CERTIFICATE OF APPROPRIATENESS

Property: 1410 Studewood Street, Lot 14, Block 112, North Norhill Subdivision. The property includes a historic 1,066 square foot, one-story wood frame single-family residence and a detached garage situated on a 5,000 square foot (50' x 100') interior lot.

Proposal: Alteration – Porch

EXISTING FRONT PORCH

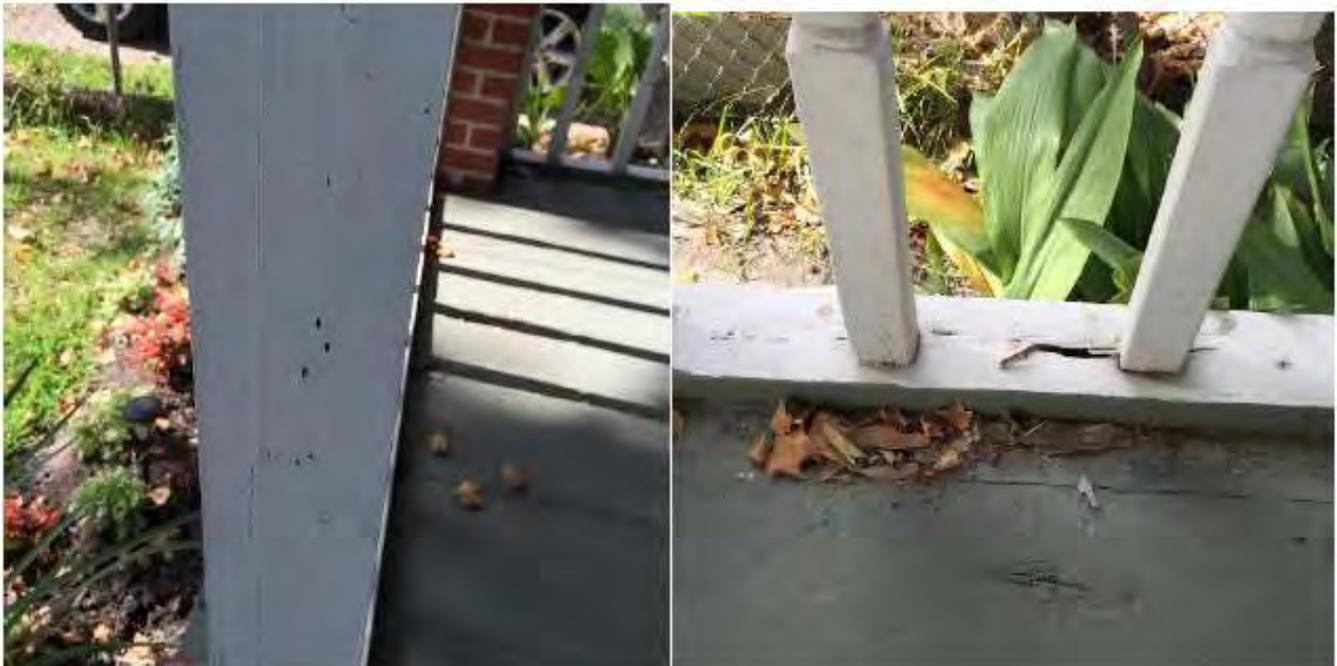
- Remove the non-original wood turned column and install a brick porch pier to match the original brick porch pier.
- Replace the existing non-original wood turned style porch guardrails with turned style post with a new wood guardrail with square posts.
- Replace the existing 2"x12" wood slat porch flooring with new wood 2"x12" wood slat porch flooring; the existing floor has rot and termite damage.
